To be held on Monday, June 1, 2015 at **2:00 p.m.** Committee Members are asked to meet in the **Council Chambers** at 395 Mulock Drive, Newmarket, Ontario.

1. Application for Amendment to Site Plan Approval p. 1
18106 and 18110 Yonge Street – Ward 7
(North of Davis Drive, West Side of Yonge Street)
Our File No.: D11-Np1508
The Regional Municipality of York

TO: Site Plan Review Committee
FROM: Linda L. Traviss, MCIP, RPP
 Senior Planner - Development
DATE: May 28, 2015
RE: Application for Amendment to Site Plan Approval – Public Information Centre
 18106 and 18110 Yonge Street
 The Regional Municipality of York

REVIEW NOTES**SITE PLAN REVIEW – 18106 & 18110 YONGE STREET**

1 SITE PLAN

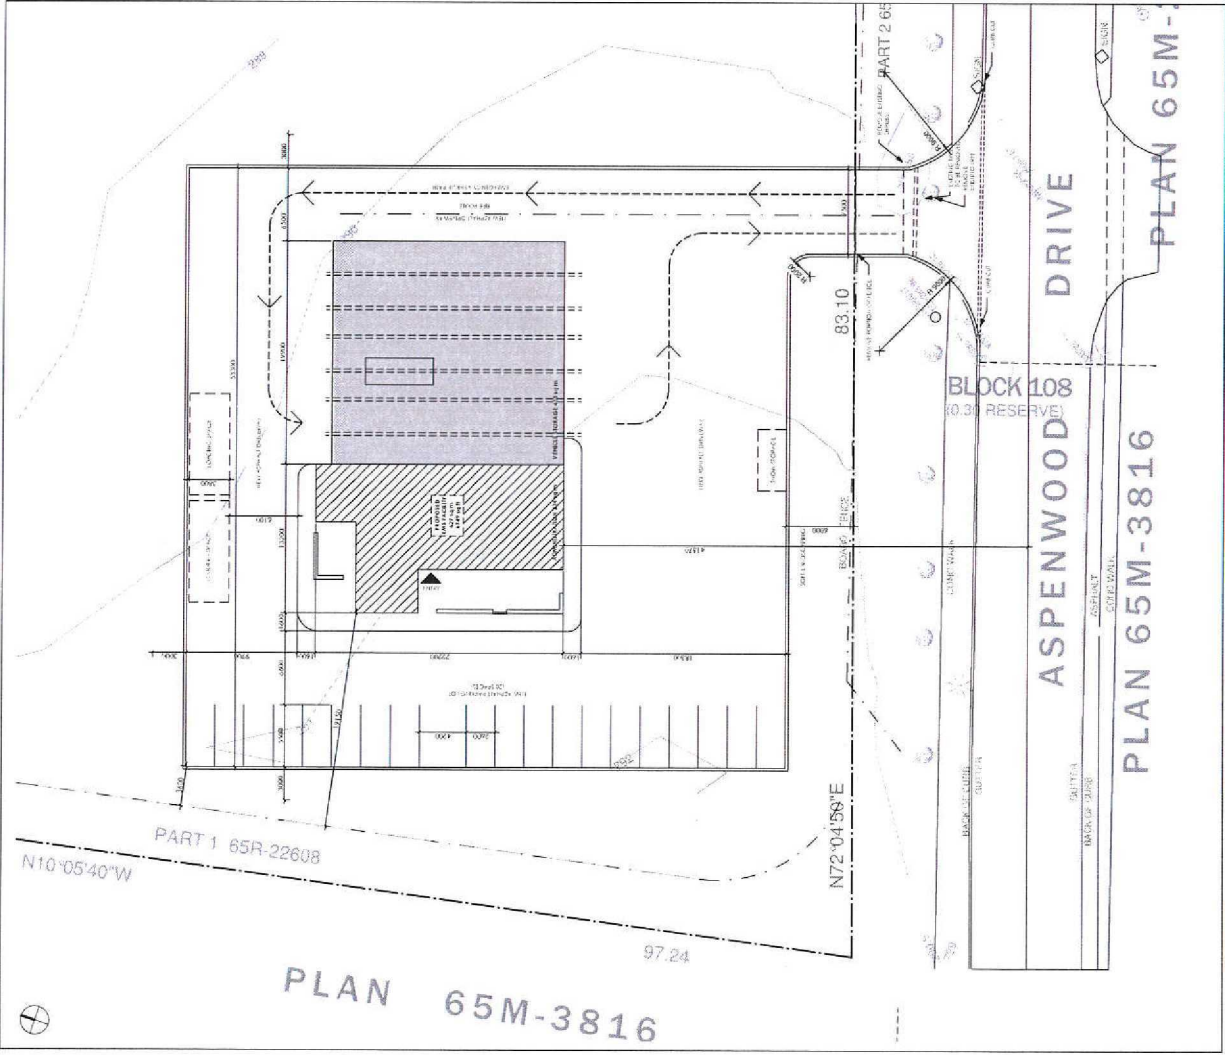
- Property is zoned Regional Urban Centre (UC-R) by By-law Number 2010-40, as amended
- As portion of property is located within Town of East Gwillimbury applicant has filed site plan approval applications with both municipalities

- Use of emergency service facility is permitted; bus garage is permitted as “public use”
- Minor Variances will be required to permit parking in exterior side yard, increase in number of parking spaces and reduction in number of loading spaces

- Traffic Briefs, Noise Studies, and Arborist Report and Tree Protection Plan will be peer reviewed
- Construction Management Plan (CMP) required prior to issuance of any building permits

- Landscaping to include a mixture of trees, shrubs and perennials along Aspenwood Street frontage
- Elements of low impact development to be incorporated into site

- Plans to be revised to indicate private hydrants on site, fire access route, Ontario Building Code Data Matrix, and siamese connections; addressing to be prominently displayed
